BELL SYSTEM PRACTICES
Teletypewriter and Data Stations

SECTION P34.322
Issue 2, December, 1961
AT&T Co Standard

28A AND 28B
REPERFORATOR-TRANSMITTER
ADAPTER UNIT
WIRING DIAGRAM

28A and 28B Reperforator-Transmitter Adapter Unit

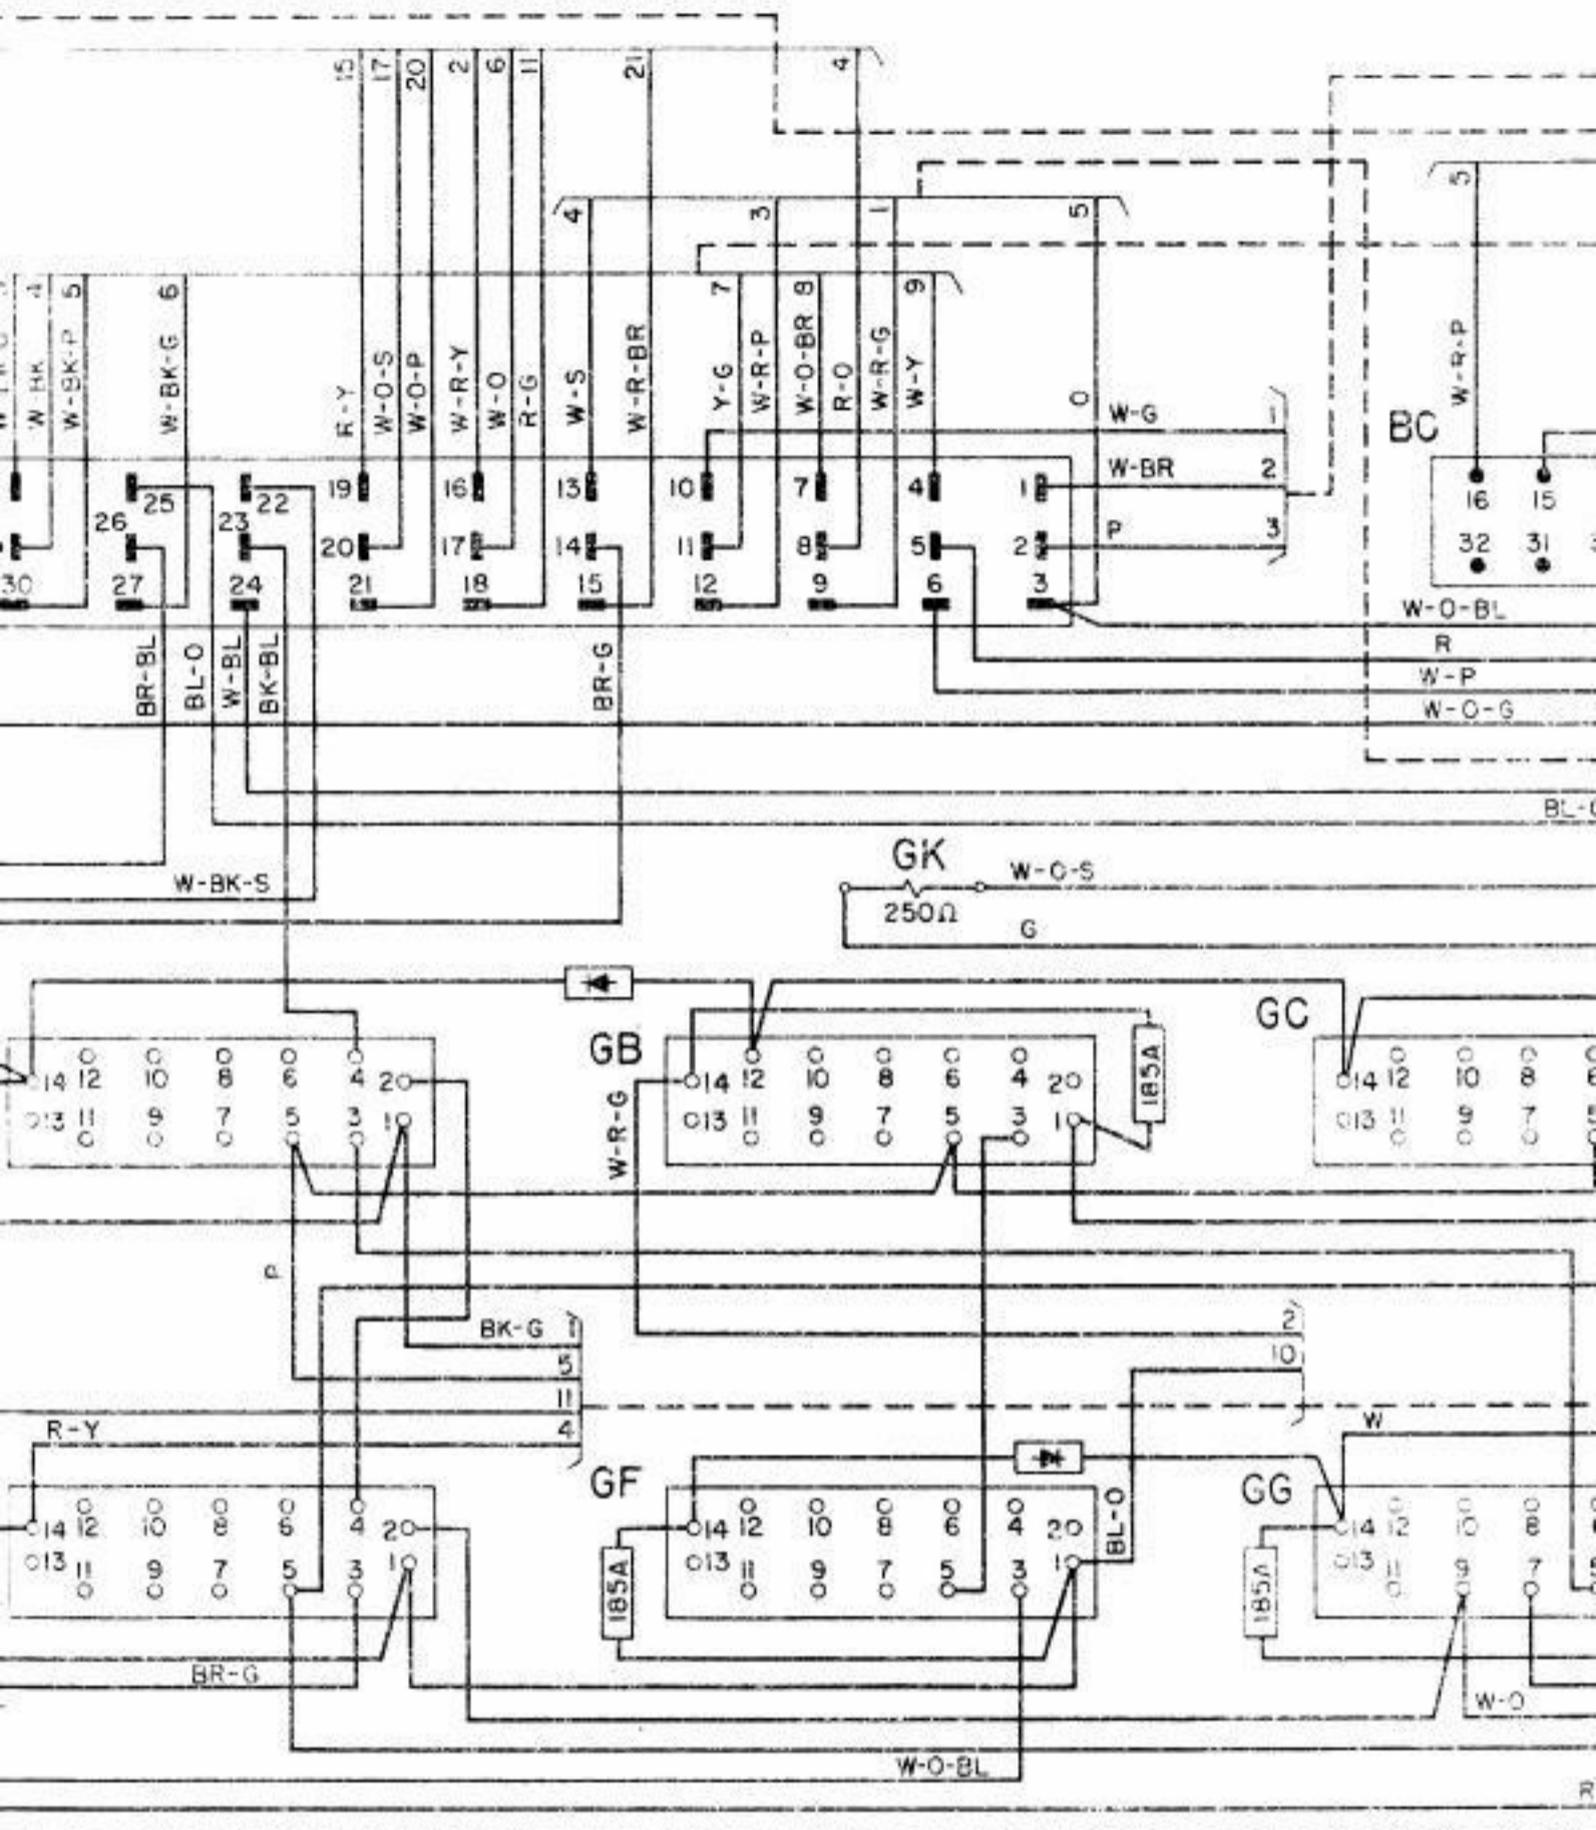
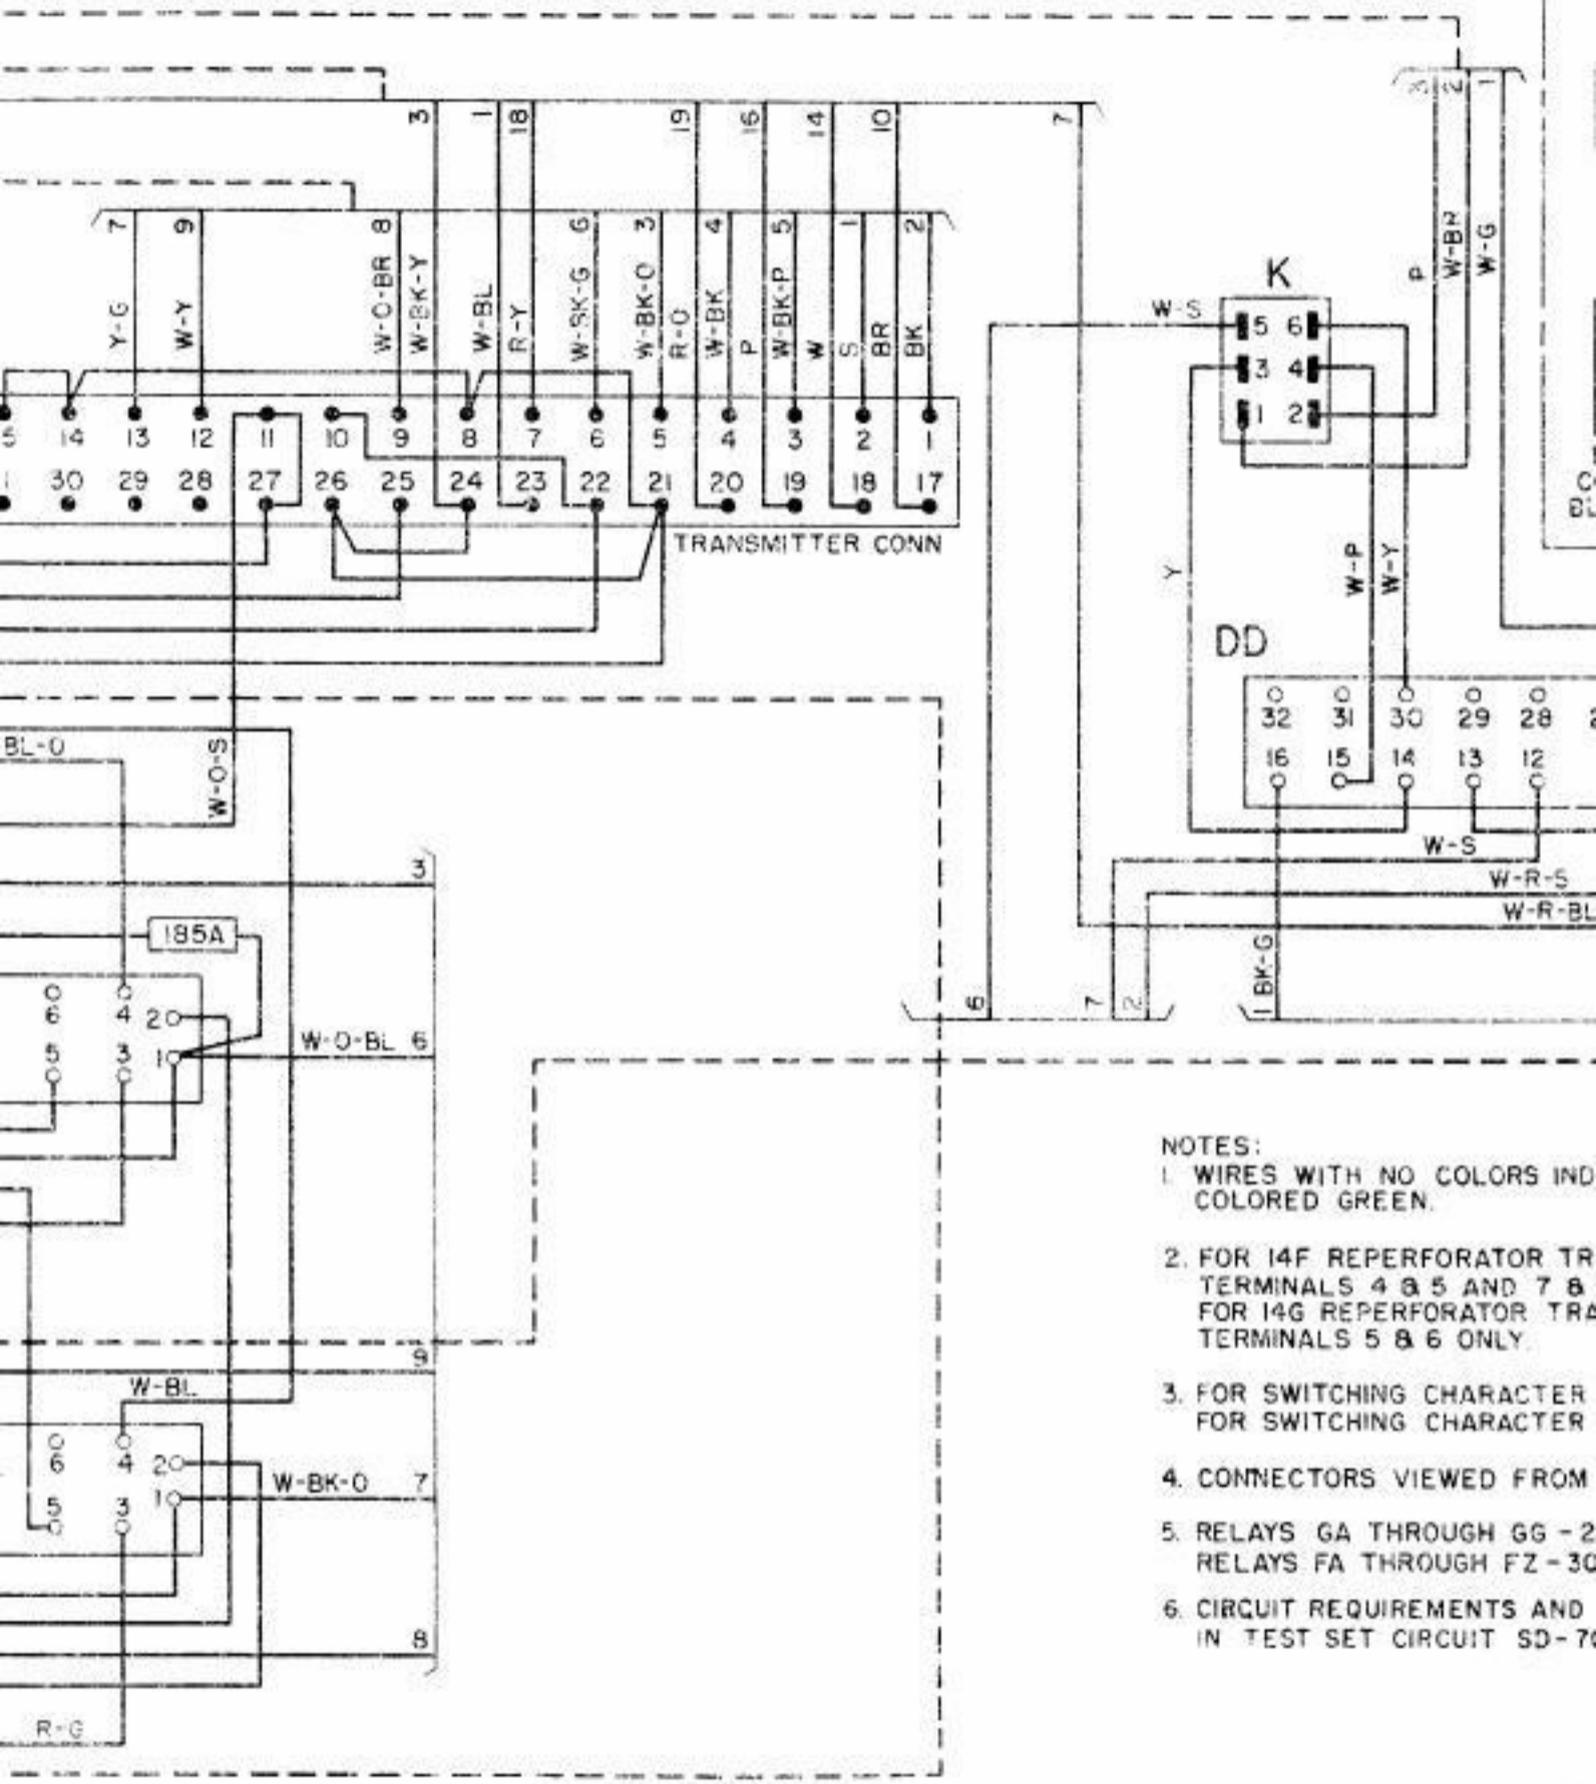
- 1.01 This section shows the wiring of the 28A and 28B reperforator-transmitter adapter unit.
- 1.02 This wiring diagram has been reissued to remove wire from FG3 to FW3 in the relay ground circuit, to change the reference of mercury relay in Note 5 to read "303F", and to add Note 6.
